REPORT ON THE SEWERAGE AND DRAINAGE
OF THE CITY OF HOBART:

REPORT BY MR. C. NAPIER BELL, M. INST. C.E.

REPORT ON THE SEWERAGE AND DRAINAGE OF THE CITY OF HOBART.

To the Chairman of the Metropolitan Drainage Board.

OUTLET AT MACQUARIE POINT ONLY
with
INTERCEPTING SEWER
FROM
ASHFIELD CREEK TO HOBART CREEK

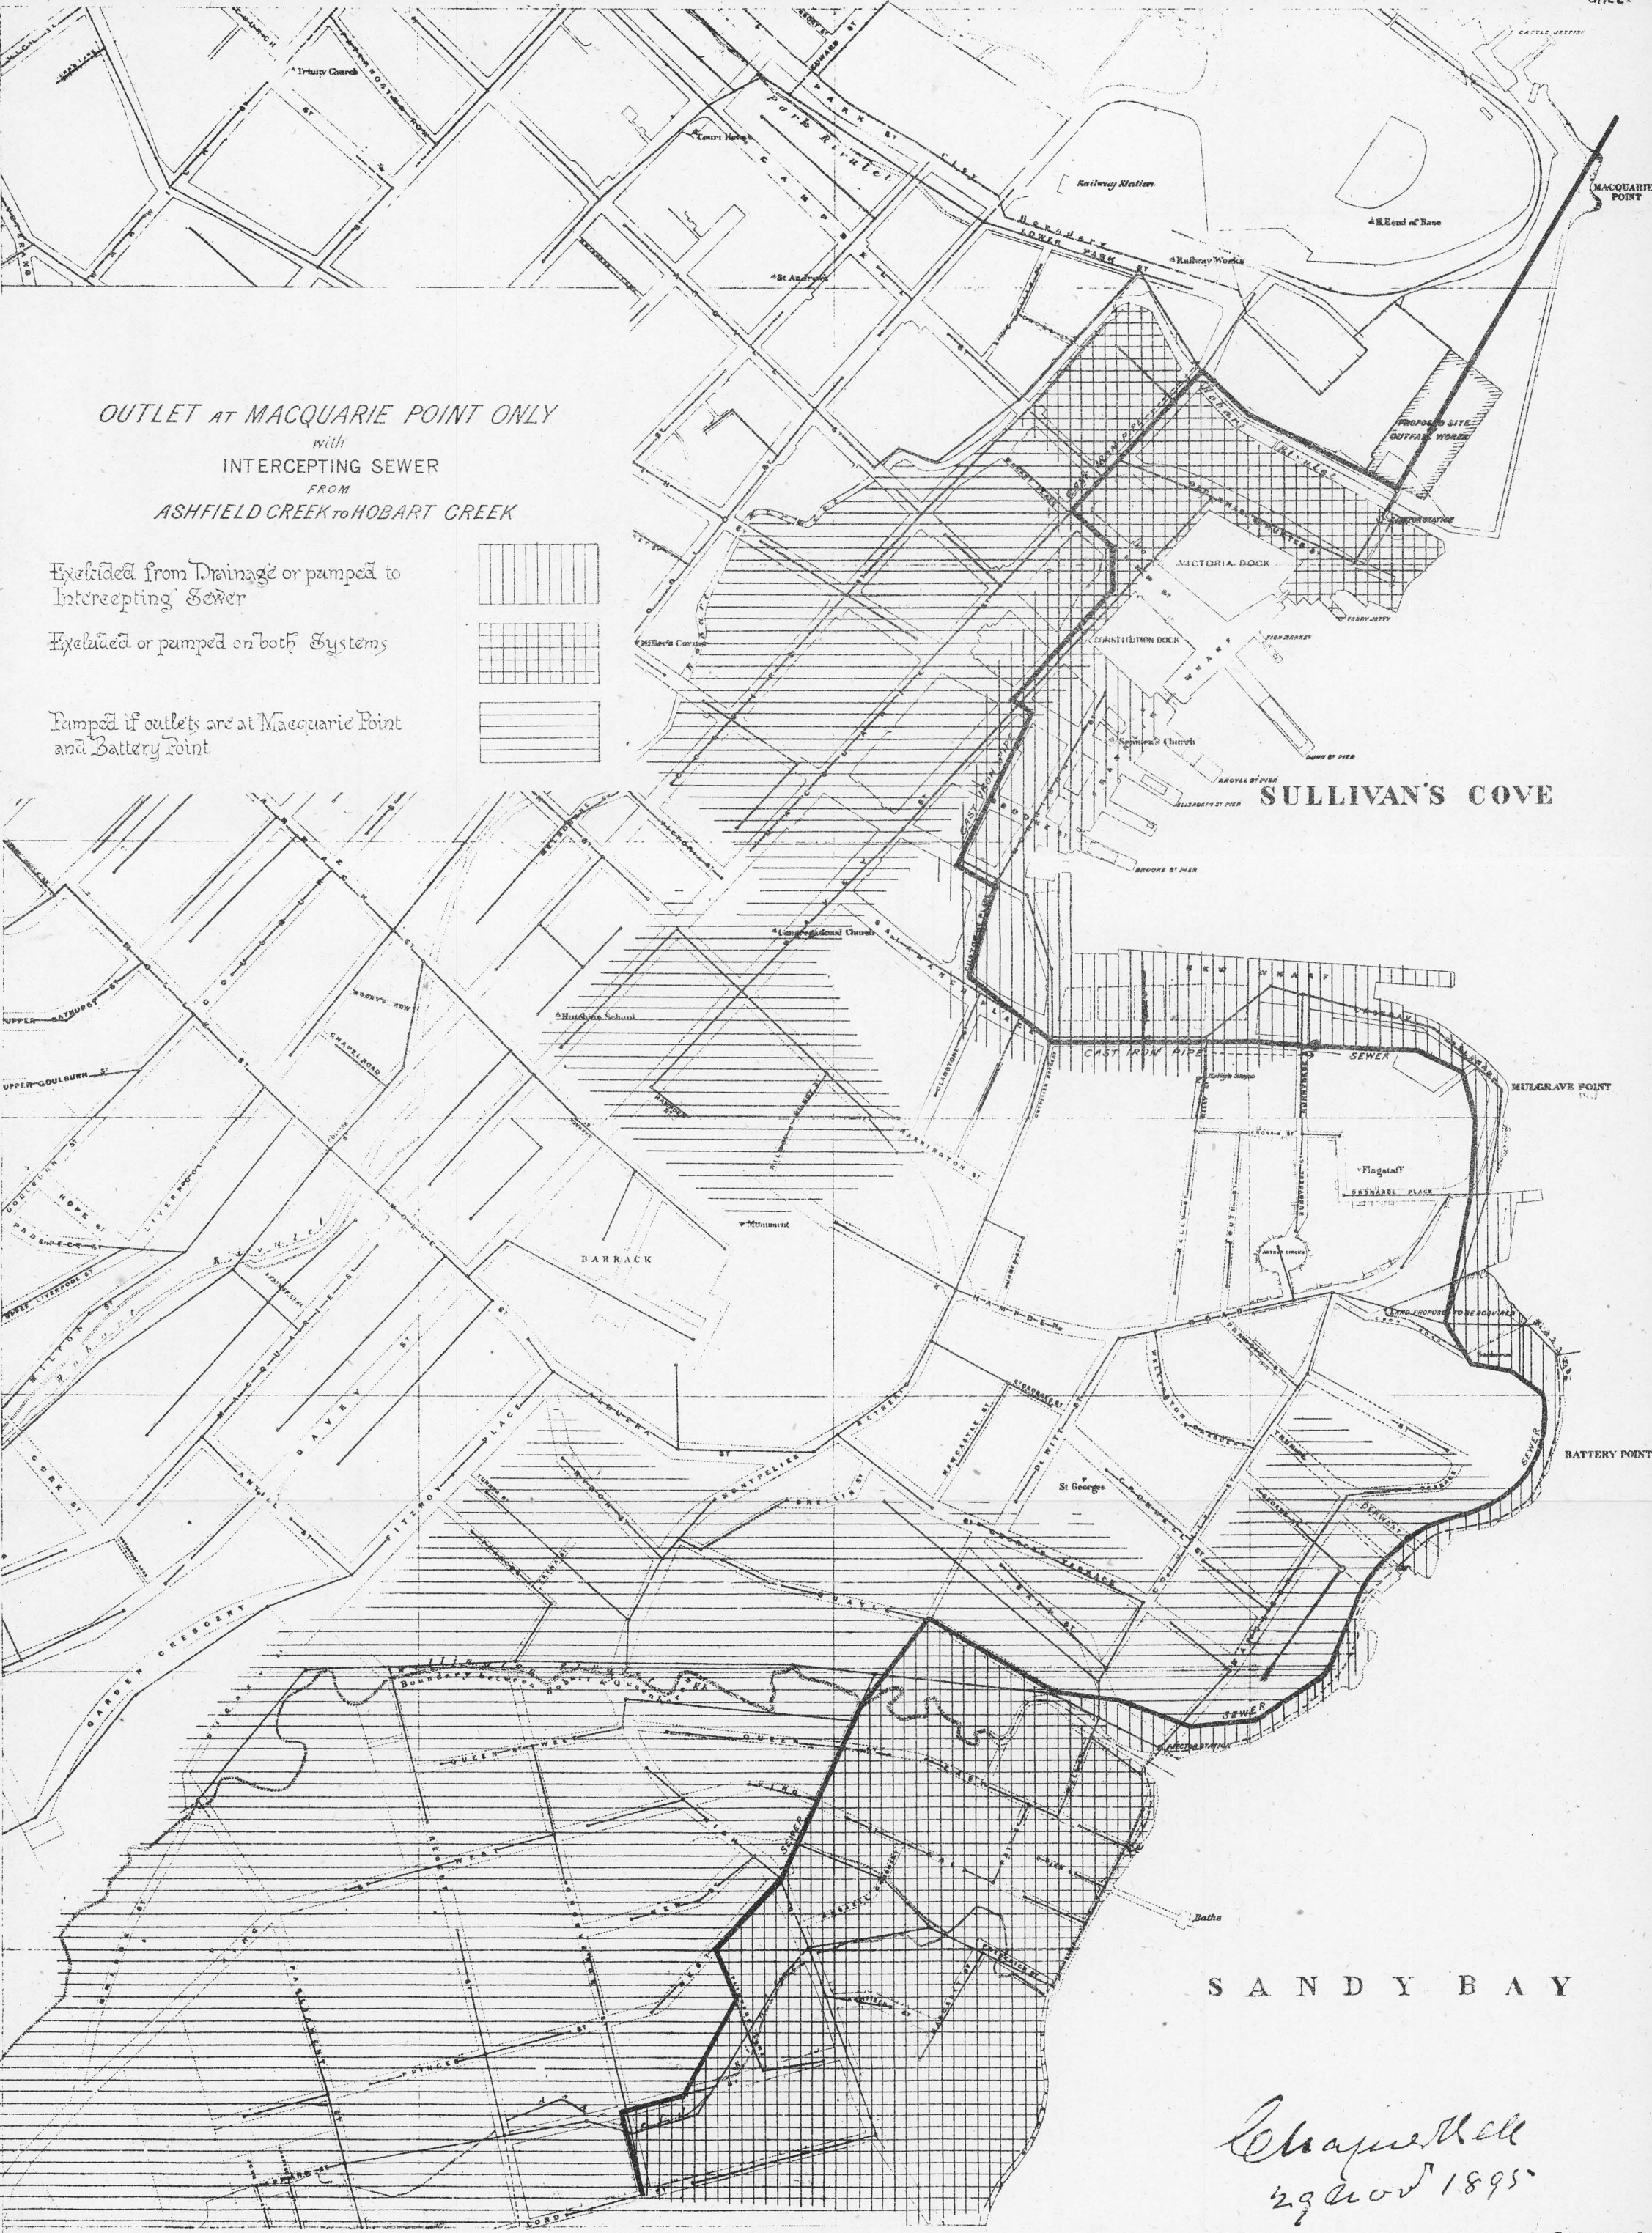
I am also in favour of doing away with pumping as far as possible, and with the object of concentrating the whole of the discharge at Macquarie Point and abolishing the necessity for pumping, I have prepared a longitudinal section of an intercepting-sewer which, commencing at Lord-street in Queenborough, and passing through Queenborough and round close to the water's edge at Battery Point, will end in a manhole at Runnymede-street; from which place to the main sewer of Mr. Mault's plan on the north side of Hobart Creek the sewage collected by this intercepting-sewer would pass under the low land which intervenes by 65 chains of pressure pipe, and discharge into the main sewer at the north end of Macquarie-street.

It will be seen by the plan which I submit herewith, showing area required to be pumped by your Engineer's plans, and those to be pumped by the intercepting sewer now proposed, that the area in the city excluded from drainage by the pressure pipe is so small that I am of opinion it might be left to drain into the harbour, while the intercepting sewer above the pressure pipe leaves no drainage out, except the part of Queenborough which lies below the level of about 30 feet above high water-mark, and this can be pumped into the intercepting sewer if and whenever it is thought desirable to do so. This intercepting sewer and pressure pipe carries all drainage to Macquarie Point, and does away with a very large area of pumping, as may be seen by inspection of the areas coloured on plan herewith.

Section of
INTERCEPTING SEWER
 ASHFIELD CREEK TO HOBART CREEK

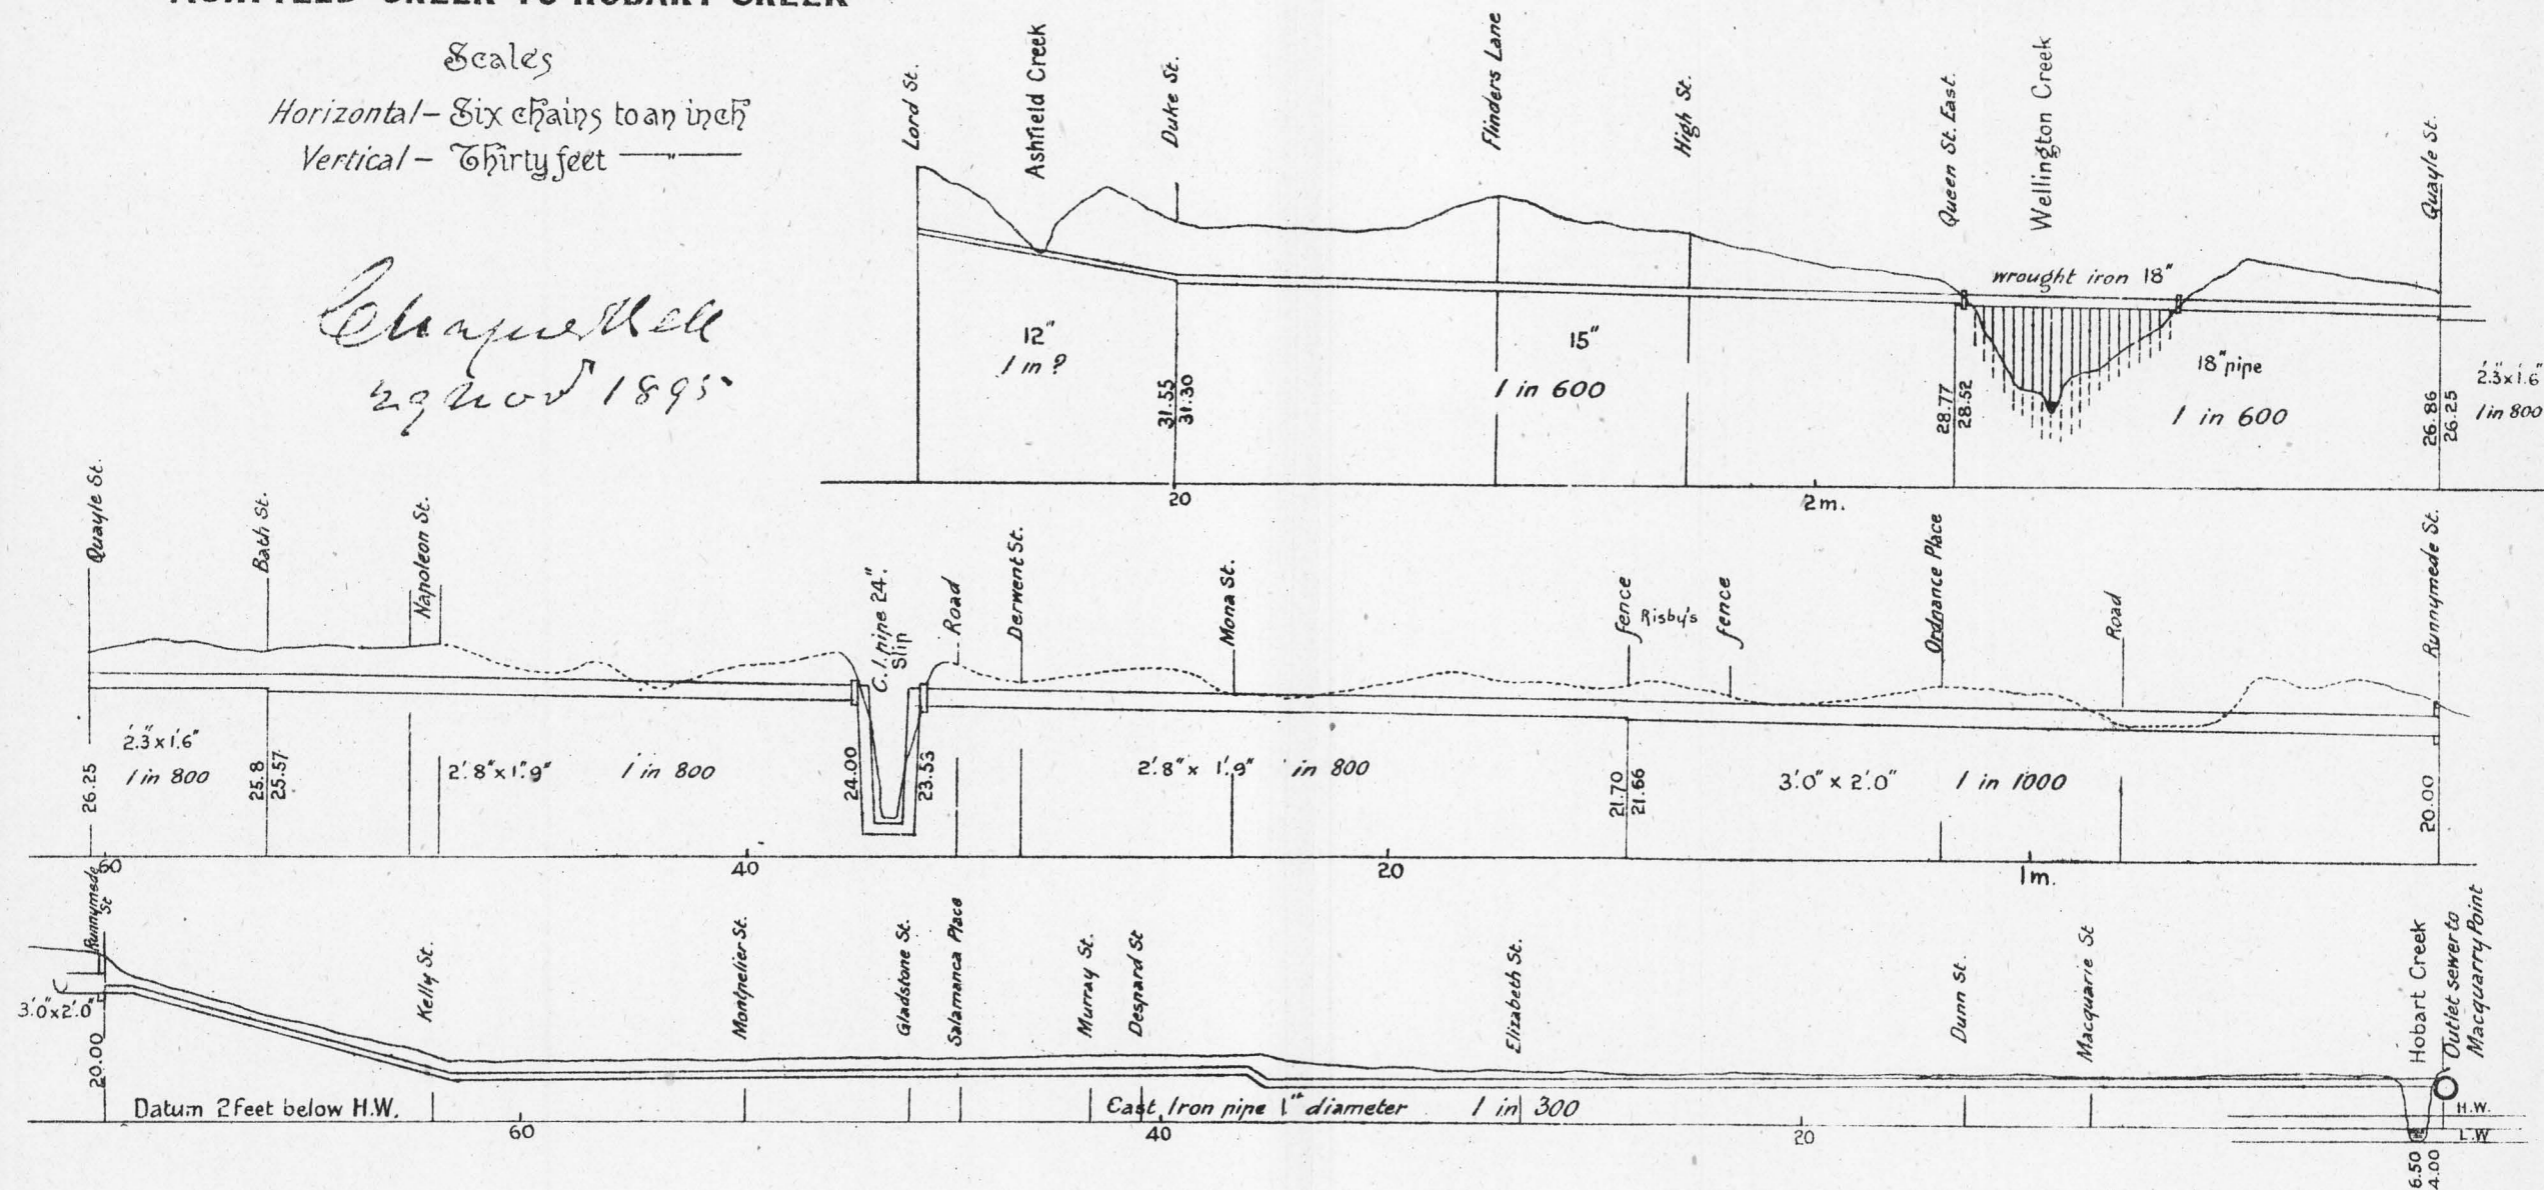
A pressure pipe of this kind is like a siphon crossing a valley, and is useful to catch the drainage off higher ground, and convey it across intervening flats. The pressure pipe will catch all drainage which lies above a straight line drawn from its inlet to its outlet, commonly called its hydraulic gradient. Wherever a street has to be drained to the pressure pipe, a pressure branch

must be carried from the pipe up the street to the height of the hydraulic gradient, at which point the drainage of the street by ordinary sewers drops into the pressure branch at what is called a "swallow," and passes into the pressure pipe and on to its outlet. This system is used in many places. It is part of the plan for the drainage of Wellington, and was recommended by the two experts and myself in the plans selected for the drainage of Dunedin.
